**ACTION TRANSMITTAL No. 2014-39**

**DATE:** June 5, 2014  
**TO:** Transportation Advisory Board  
**FROM:** Technical Advisory Committee  
**PREPARED BY:** Carl Ohrn, Planning Analyst 651-602-1719  
**SUBJECT:** Scope Change for Hwy 61 and Hwy 97 Reconstruction and Roundabout  
**REQUESTED ACTION:** MnDOT requests a scope change to modify the scope of SP 8206-45 to eliminate one grade-separated pedestrian crossing and add various pedestrian facilities. The total project costs increase to \$7,082,697 with \$5,376,000 federal Surface Transportation Program (STP) funding and \$1,744,000 MnDOT and other funding in 2016.  
**RECOMMENDED MOTION:** Recommend approval of the request to modify the scope and project cost for Hwy 61 and Hwy 97 project described above.

RE: SP 8206-45 Hwy 61 & Hwy 97 Reconstruction and Roundabouts – Scope Change Request

**(4) HYBRID GRADE SEPARATED AND AT-GRADE ALTERNATIVE**  
 SUBJECT TO CHANGE 05-01-14

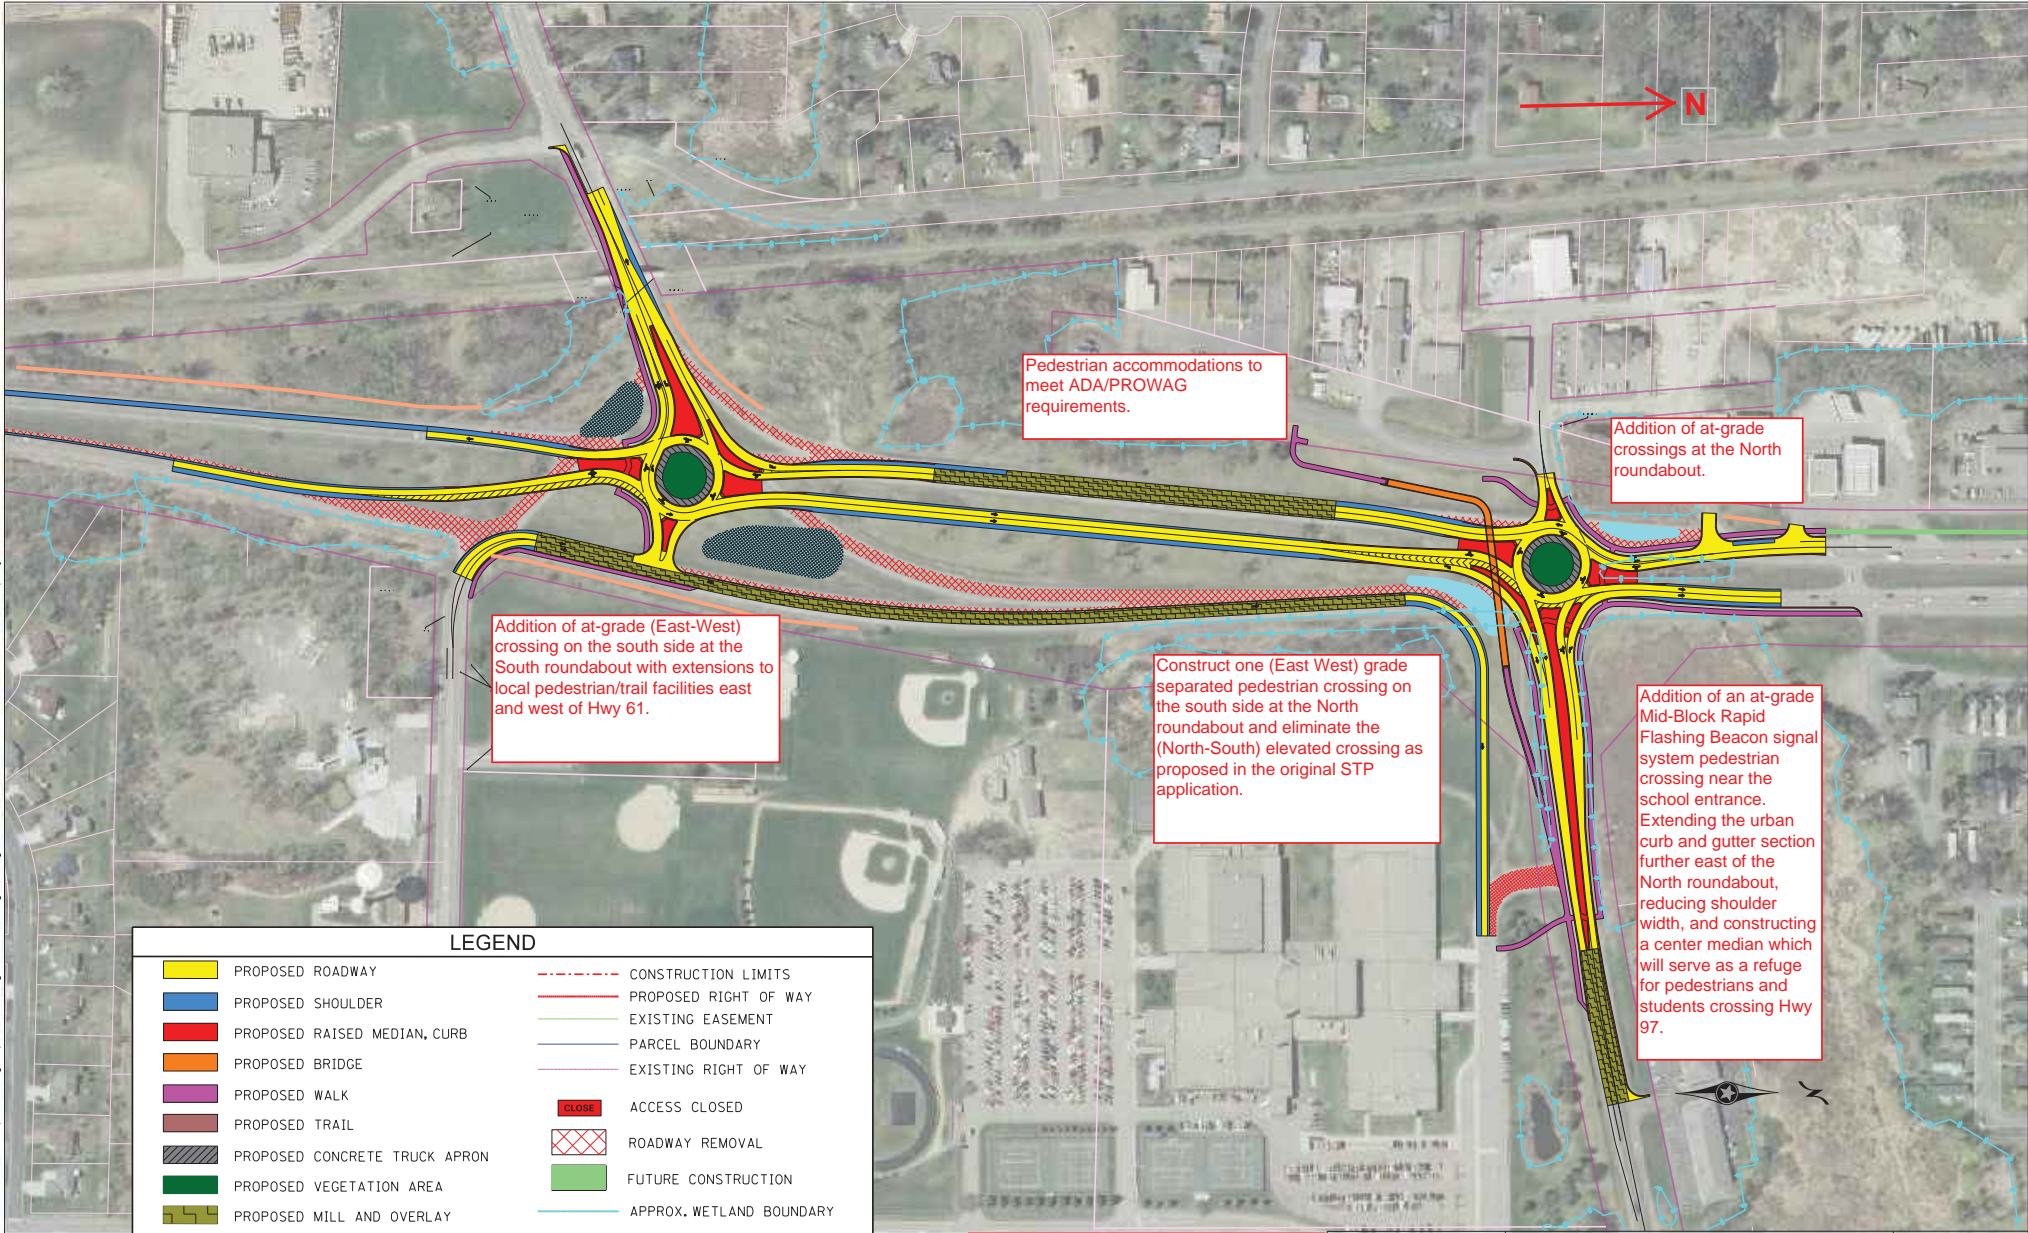
Pedestrian accommodations to meet ADA/PROWAG requirements.

Addition of at-grade crossings at the North roundabout.

Addition of at-grade (East-West) crossing on the south side at the South roundabout with extensions to local pedestrian/trail facilities east and west of Hwy 61.

Construct one (East West) grade separated pedestrian crossing on the south side at the North roundabout and eliminate the (North-South) elevated crossing as proposed in the original STP application.

Addition of an at-grade Mid-Block Rapid Flashing Beacon signal system pedestrian crossing near the school entrance. Extending the urban curb and gutter section further east of the North roundabout, reducing shoulder width, and constructing a center median which will serve as a refuge for pedestrians and students crossing Hwy 97.
